Subdivision and Land Development Cover
Page for SLD # 02-24

Project Name:
Villanova Boathouse

**RE: SLD#02-24: Villanova Boathouse at 601 Washington Street
Sketch Plan / Land Development of Boathouse Modification and Parking Improvements
Zoning Ordinance Compliance Review Letter**

RE: Sketch Plan Review
601 Washington Street
Whitemarsh Township, Montgomery County, PA
S/LD # 02-24
Our Project Number 2024-00243

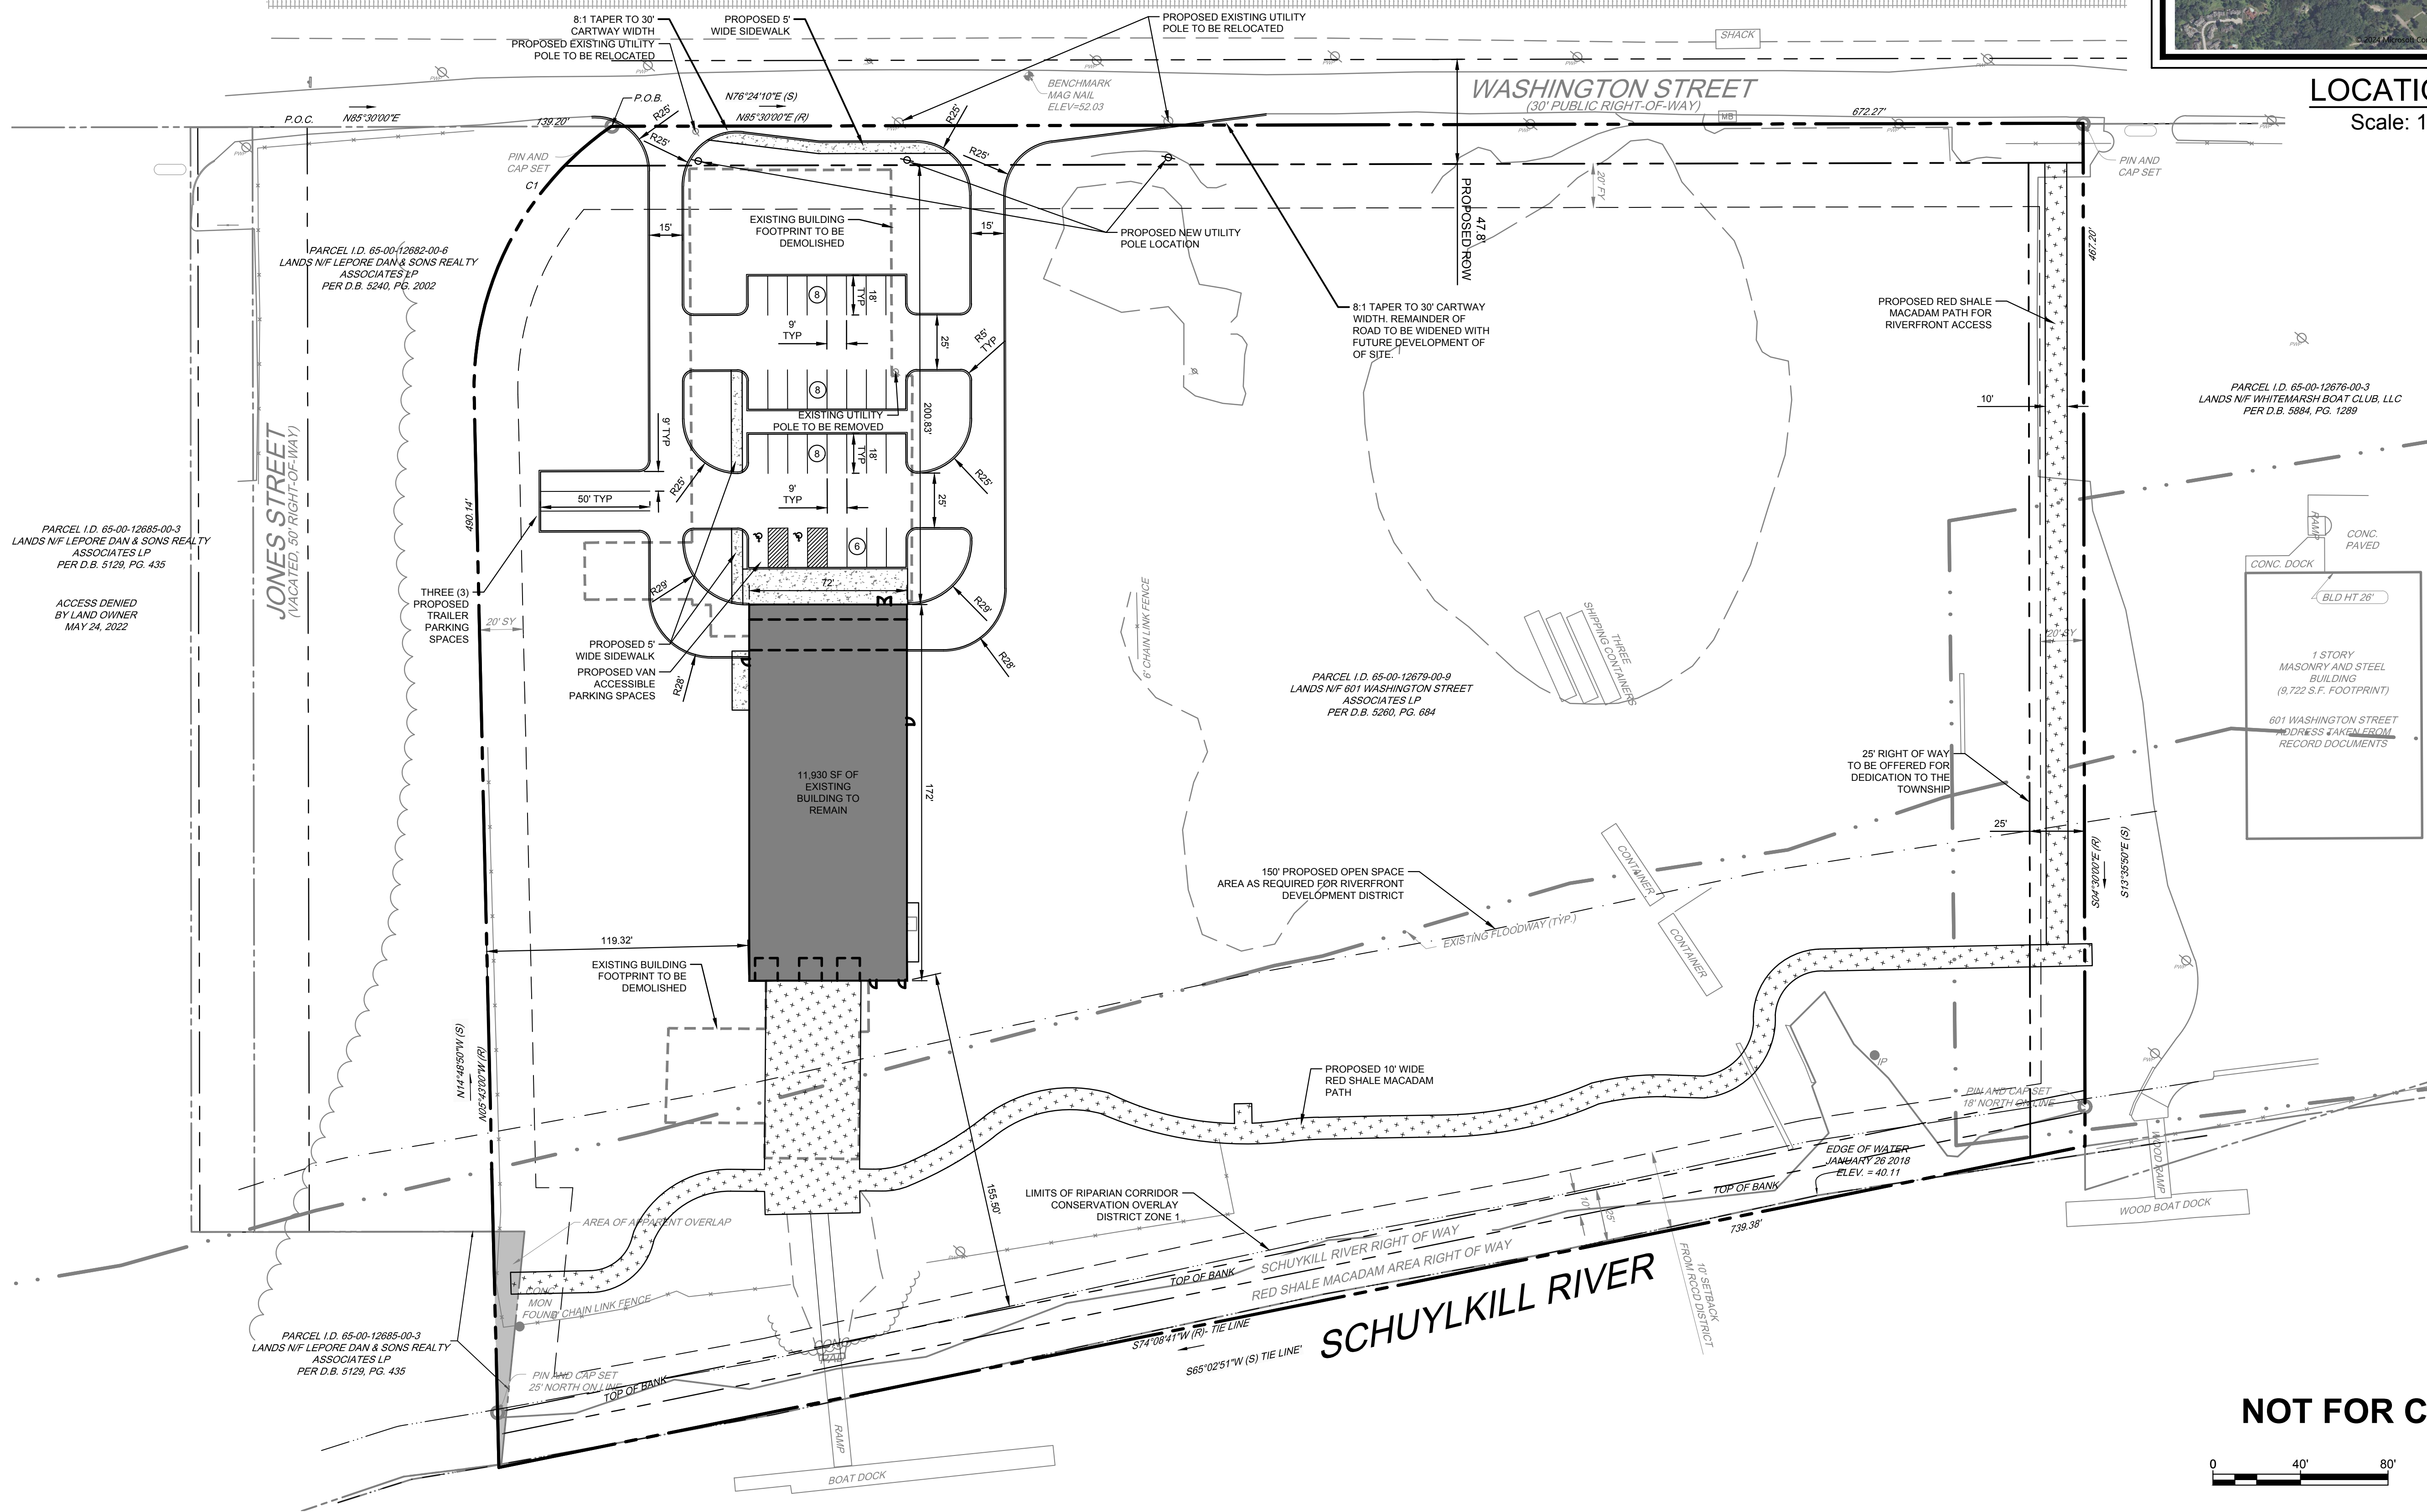
<u>Section</u>	<u>Description</u>
1.	105-20(A)(4)	The Zoning Compliance Summary Table must be revised to indicate that the site is located within the RDD-1 (instead of RDD) Overlay District.

SITE PLAN

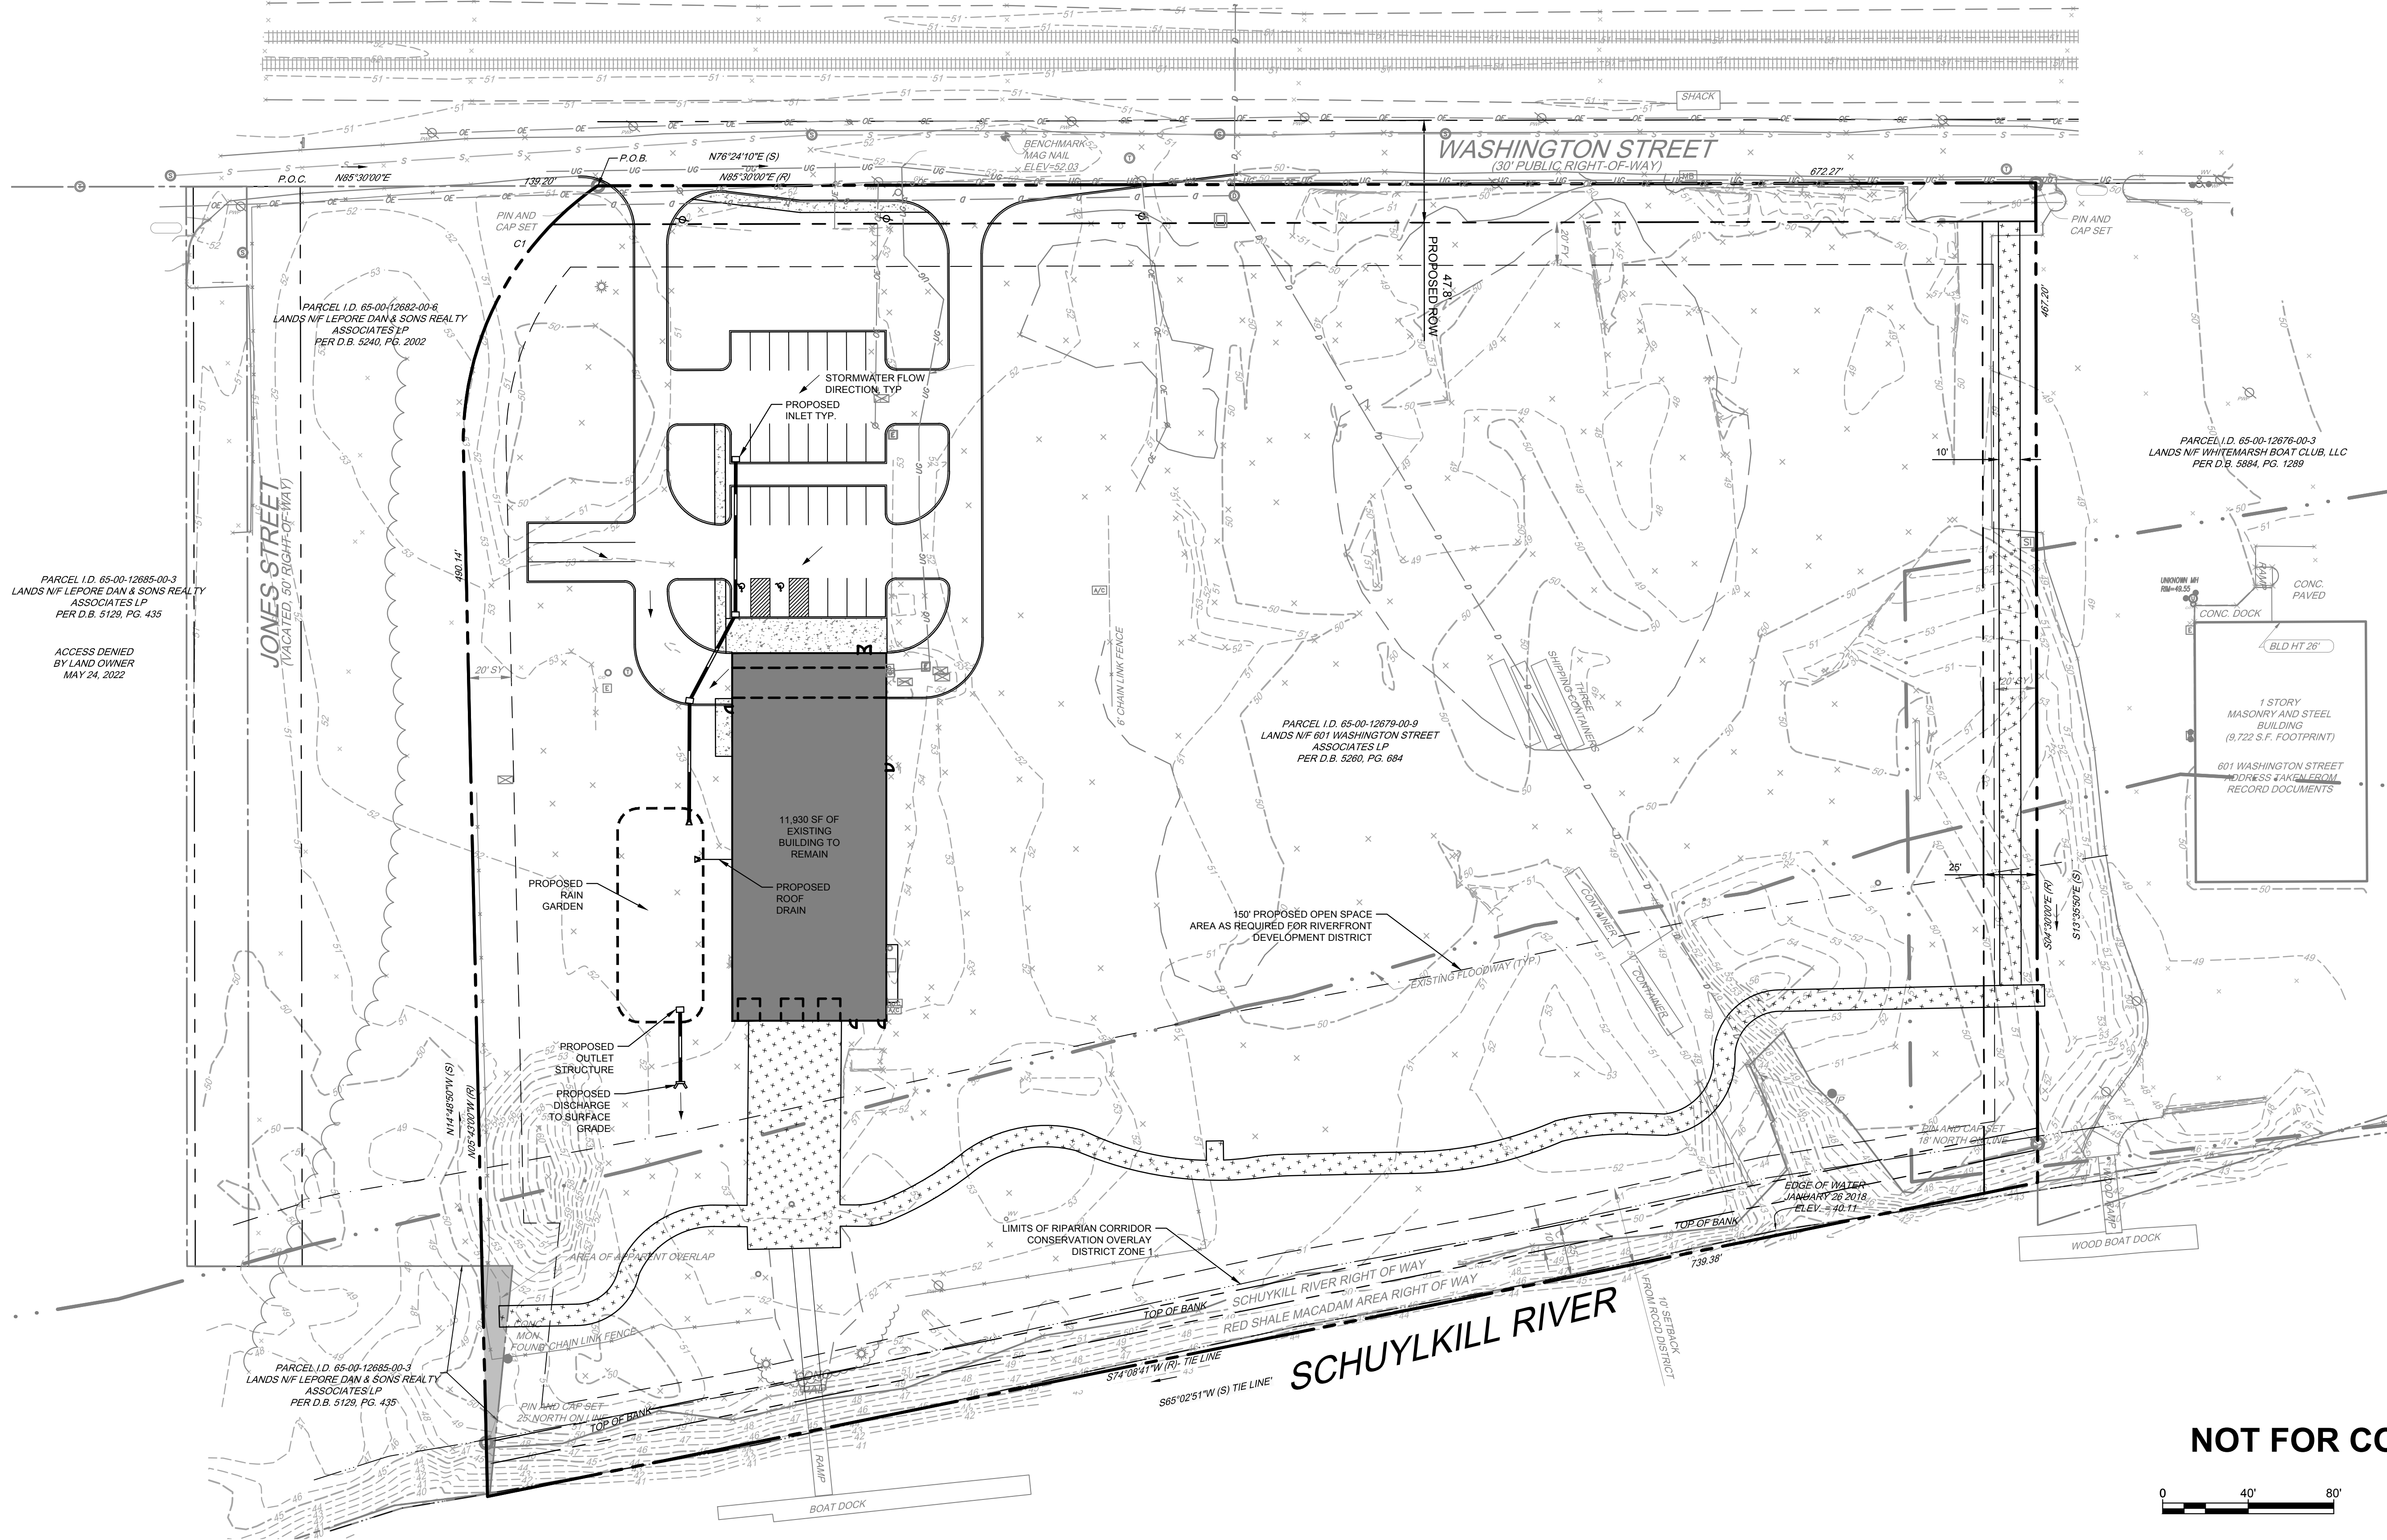
5. §116-161.A. A note must be added to the plans which indicates that the entire property is located within the Floodplain Conservation Overlay District.

11. §116-184.A. The applicant must indicate what specific use in the list within this section, was used as the basis to determine the required number of parking spaces. Based on said use, the number of spaces required, and the number proposed, must both be indicated on the plan.

20. §116-281.A.(3)(a) This section requires that the minimum building setback from the ultimate right-of-way (of Washington Street) be 10 feet with an average of 20 feet. As proposed, the location of the reduced-scale boathouse will not meet these requirements, thereby requiring a variance from this section. Also as noted in Comment #1, the proposed (ultimate?) right-of-way dimension of 47.8 feet is unclear.

- 8. Will the current containers shown on the sketch plan remain on site or are they being removed with the project?
- 9. Will the other boat access by the containers remain or is that being removed? If the other boat access is staying, will it be made accessible to first responders?

2.	105-20(A)(10)	The plans must be revised to show the boundaries of all adjoining properties with names of landowners, including those across Washington Street.

<u>Section</u>	<u>Description</u>
6.	105-20(B)(1)	The plans must be revised to show proposed finished grades.
7.	105-21(B)(1)(l)	The plans indicate an “area of apparent overlap” at the Southwestern Corner of the site. Property Boundaries must be resolved and properly monumented prior to final plan approval.

8.	105-20(B)(2)	The plans must be revised to note the base flood elevation (BFE) consistent with FEMA Flood Insurance Maps and Surveys, which designate the base flood elevation as being at approximately elevation of 59.5.
